Re: Second Submission Review: Parklands Village 1 Phase 2 – Site Plan and Plat
Application Number: DA-2289-06
Case Numbers: 2024-4015-00; 2024-3028-00

PARKLANDS VILLAGE 1 SITE PLAN NO. 2

PARKLANDS VILLAGE 1 SUBDIVISION FILING NO. 2

SITE PLAN DETAILS

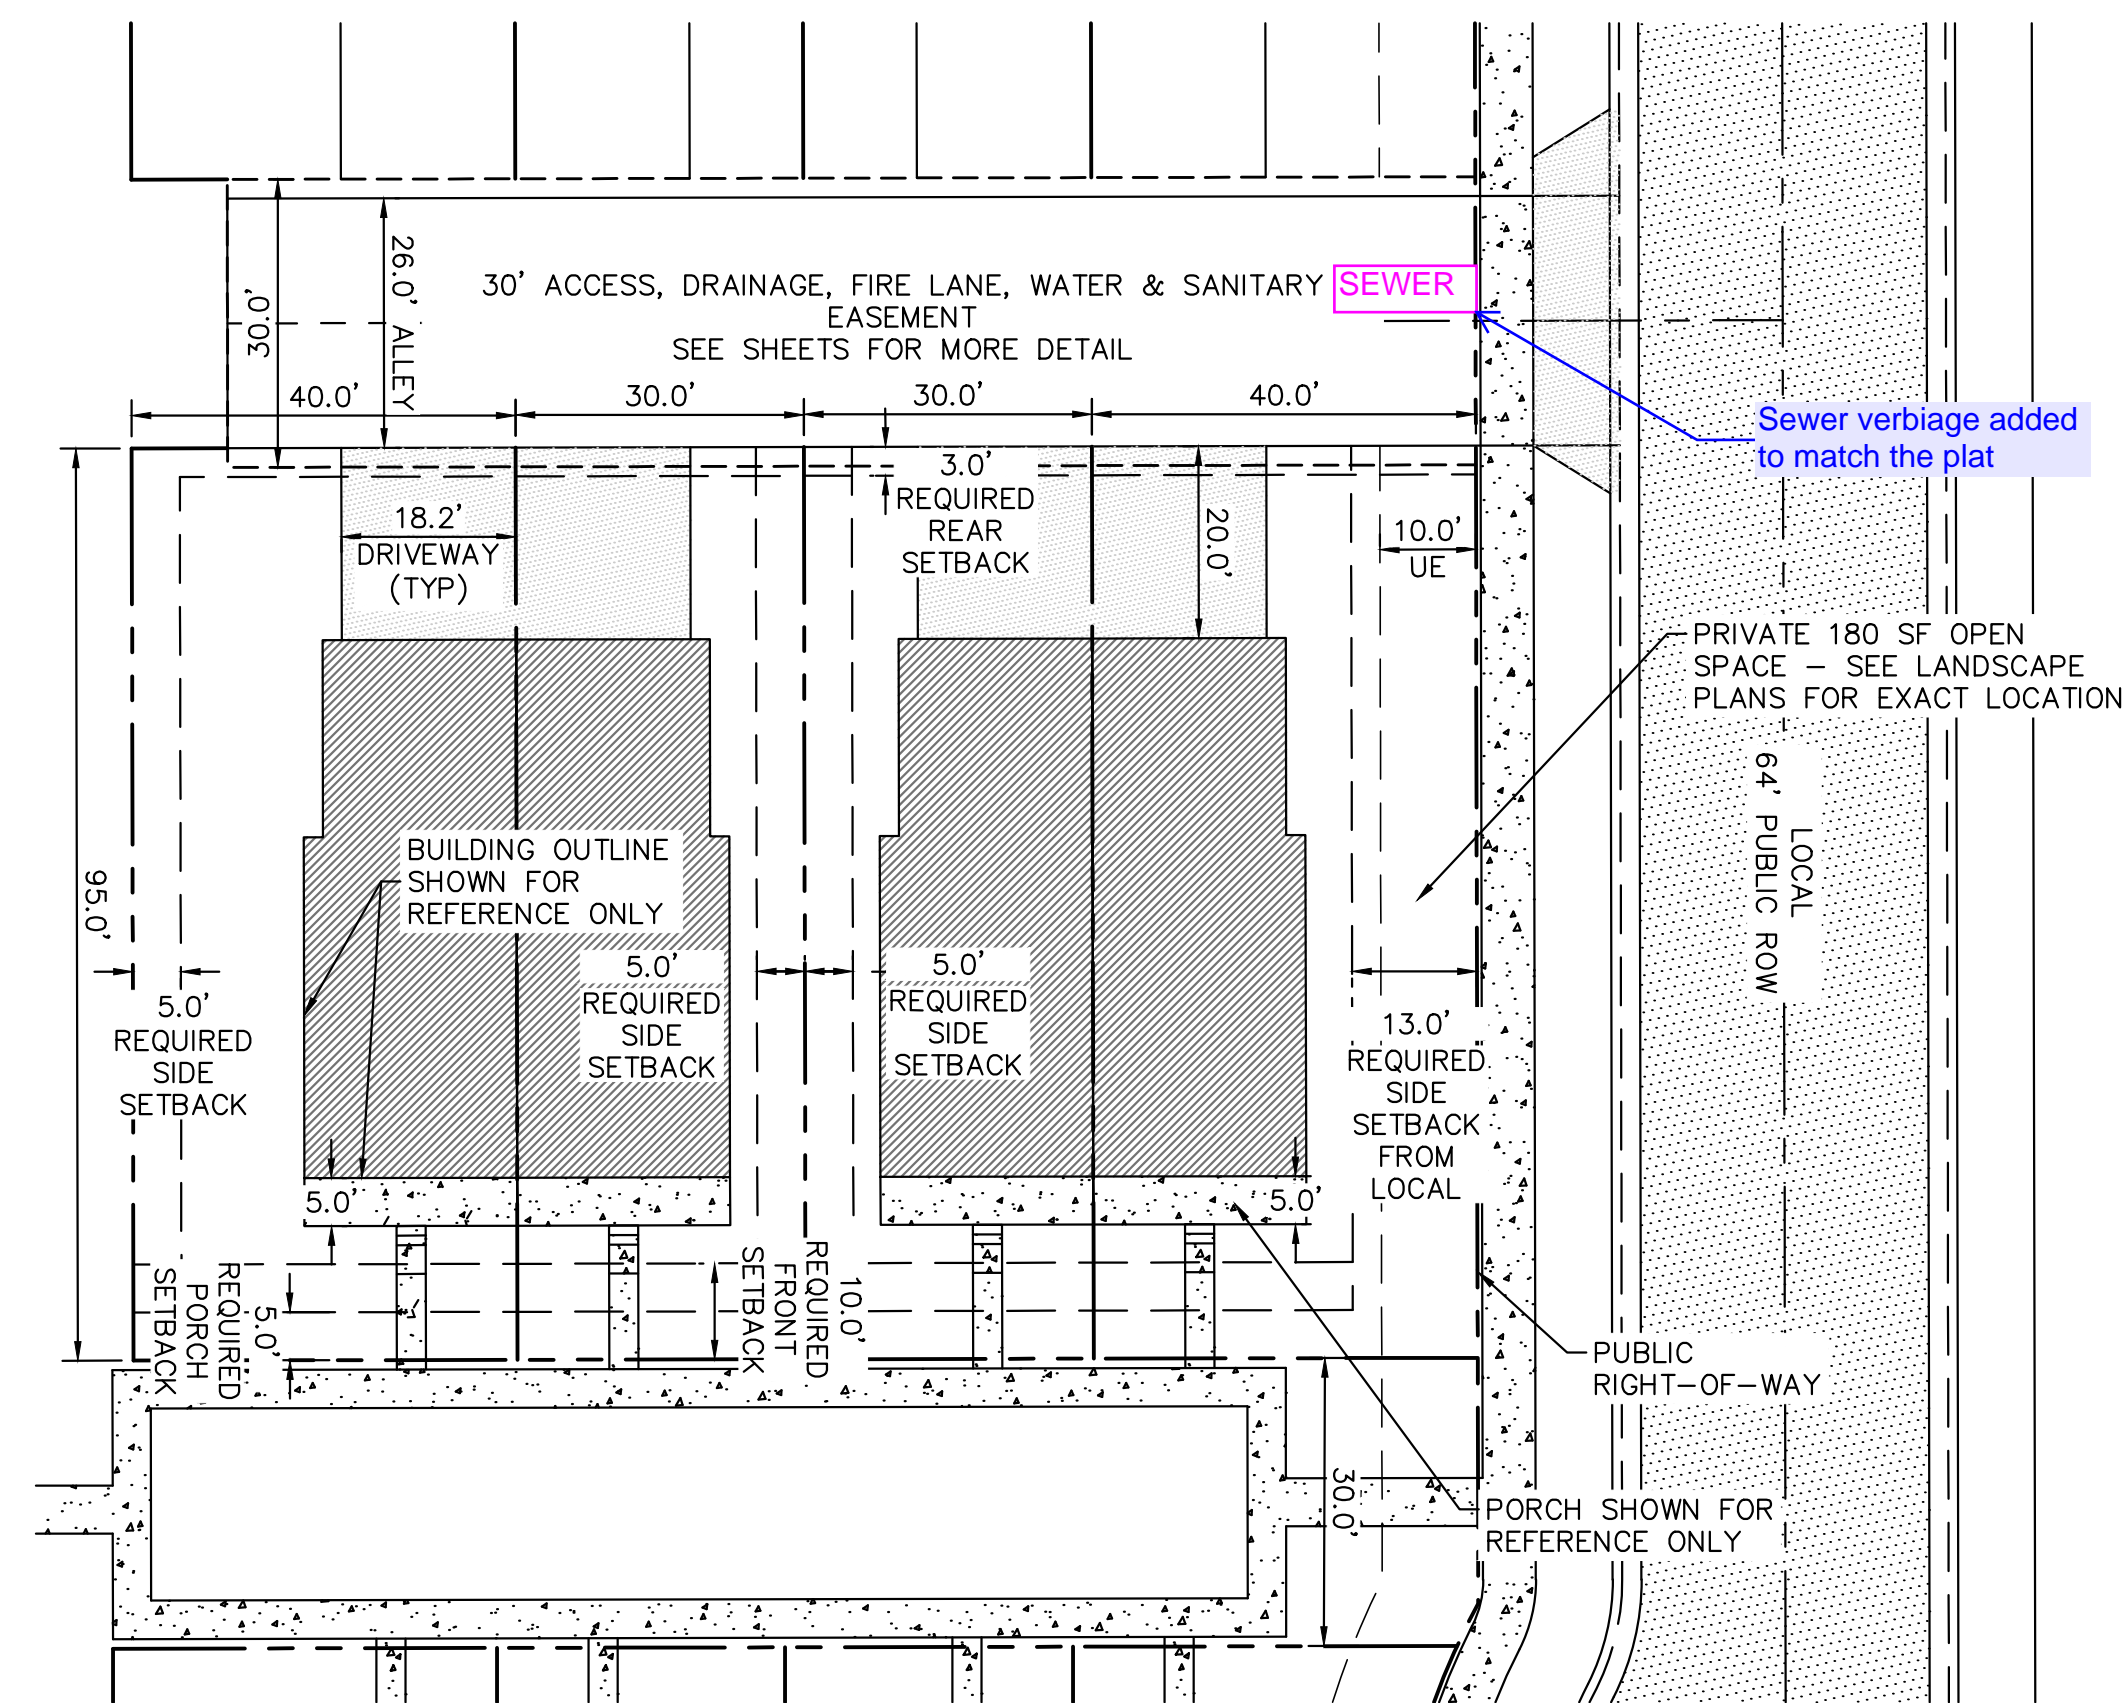
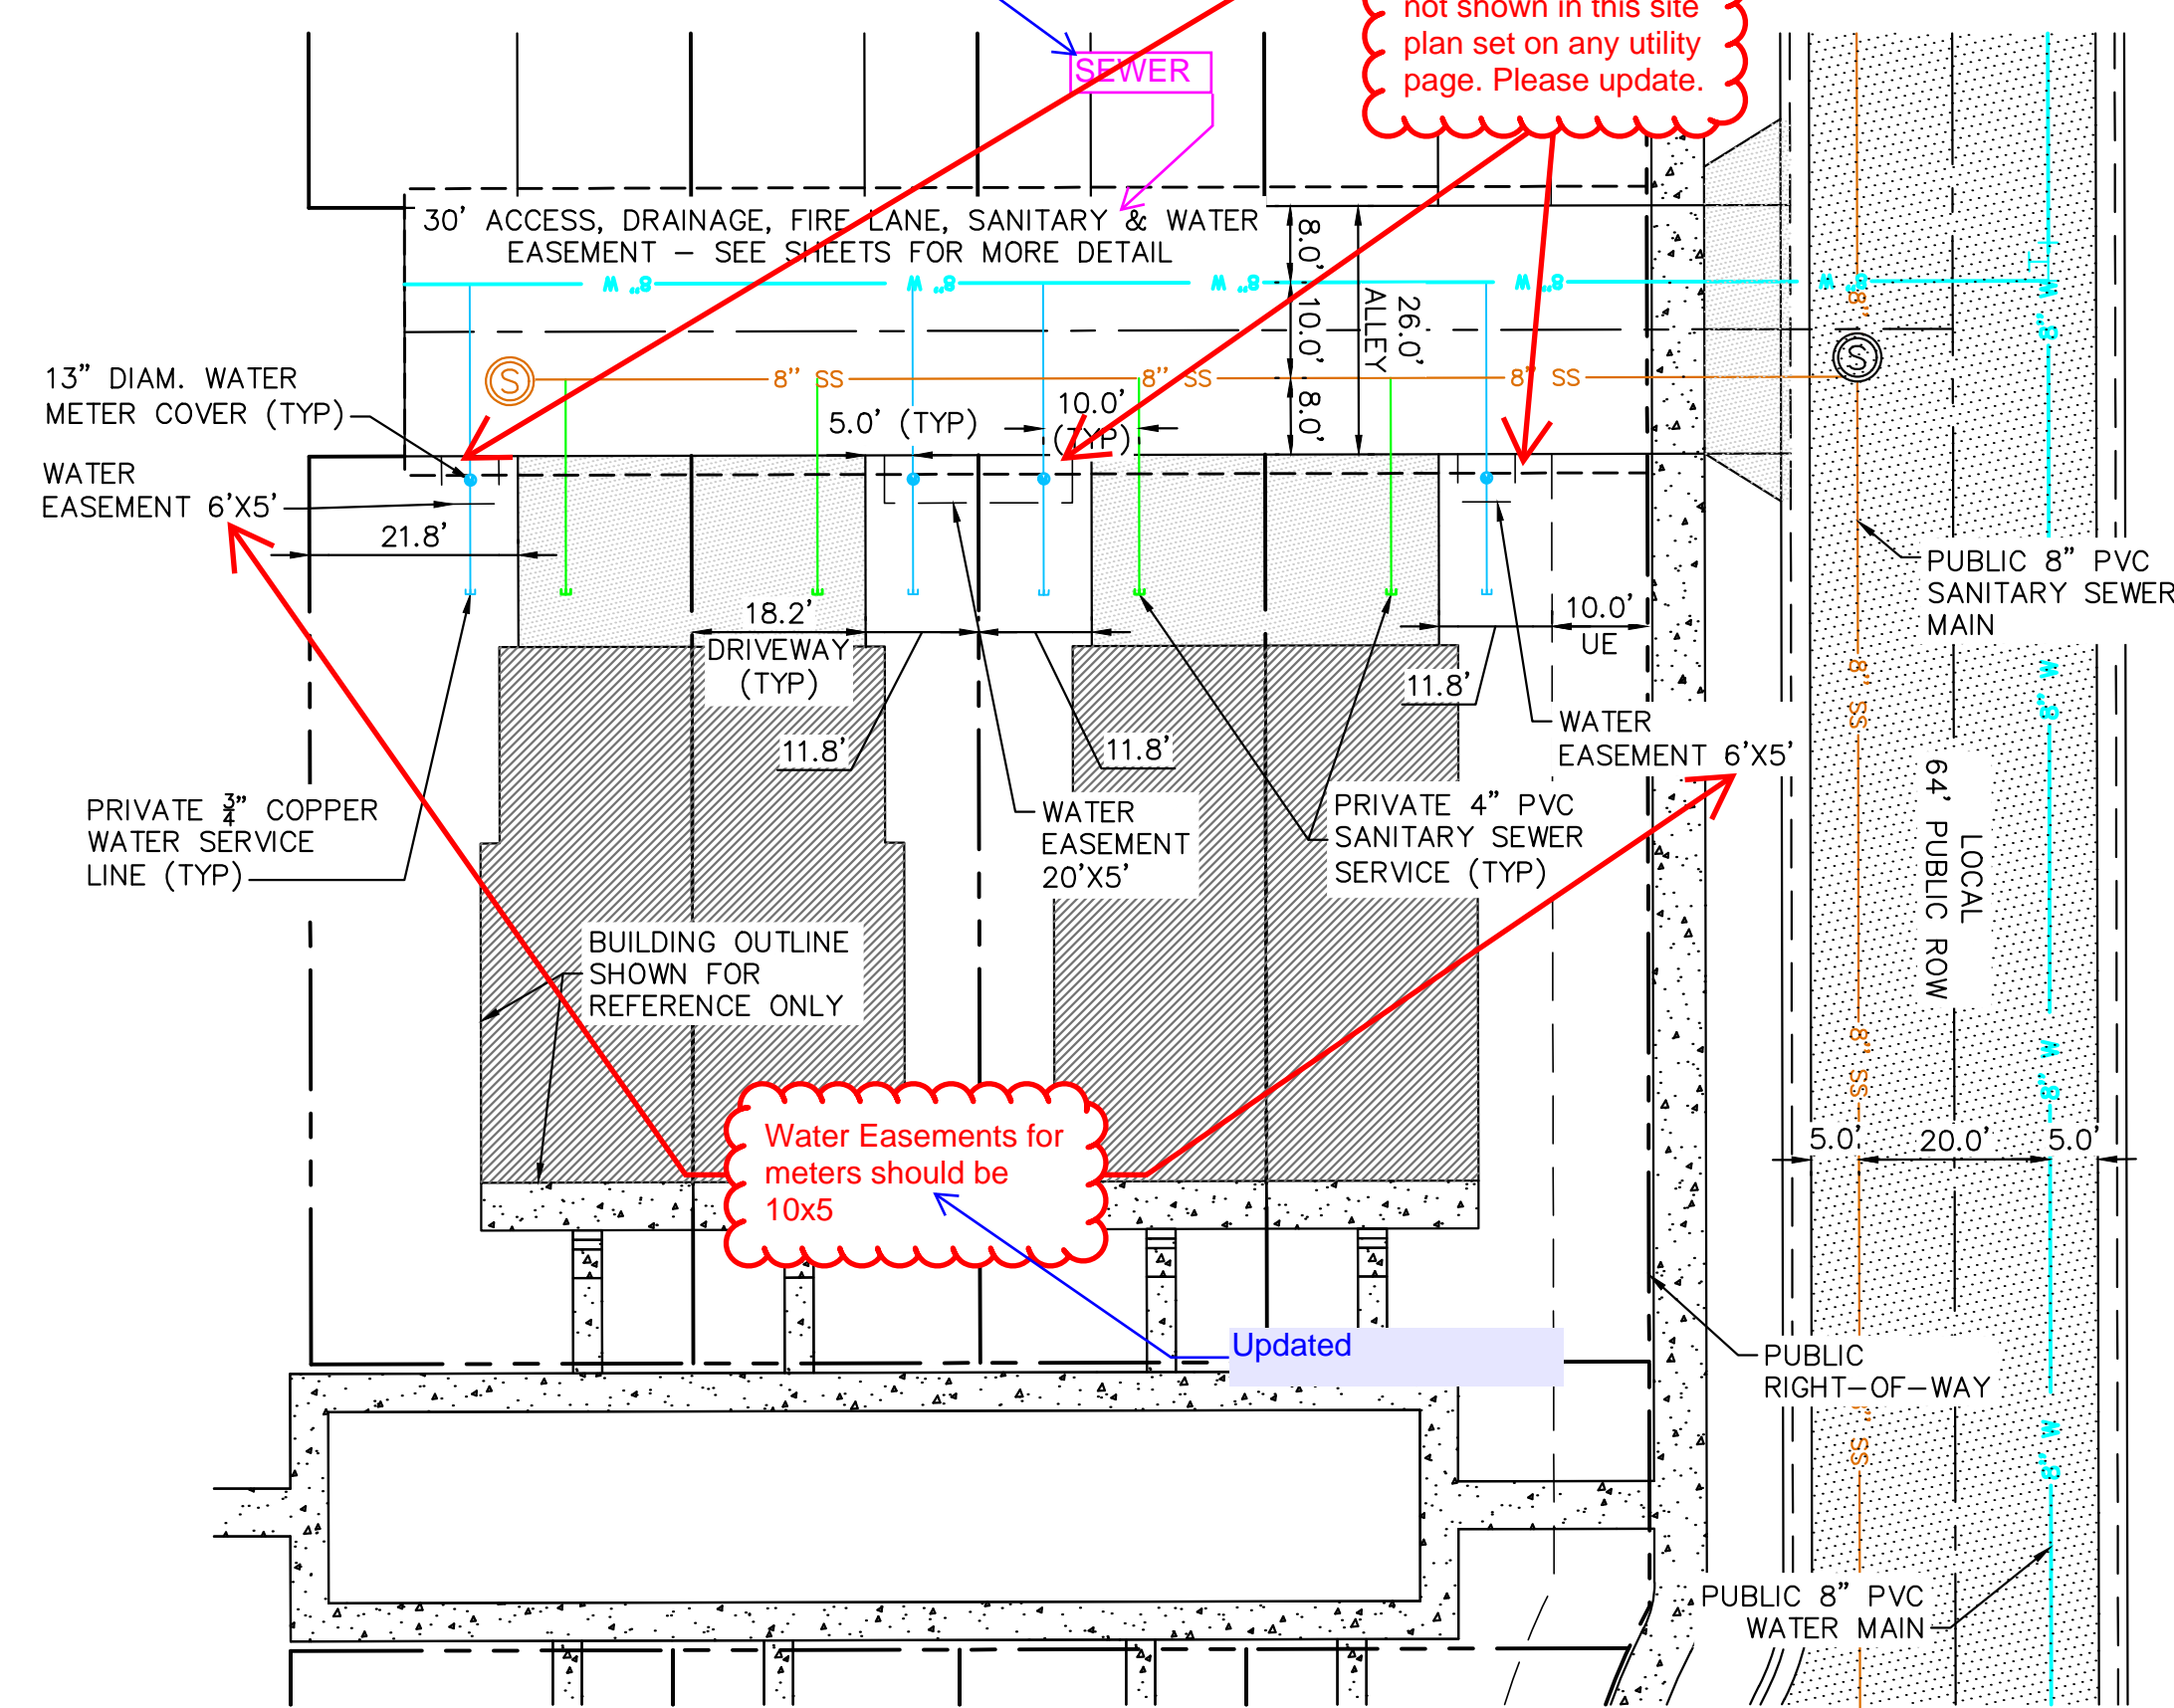
- These water easements for meters are not shown on the plat. They are also not shown in this site plan set on any utility page. Please update.

Easement label added to align with plat
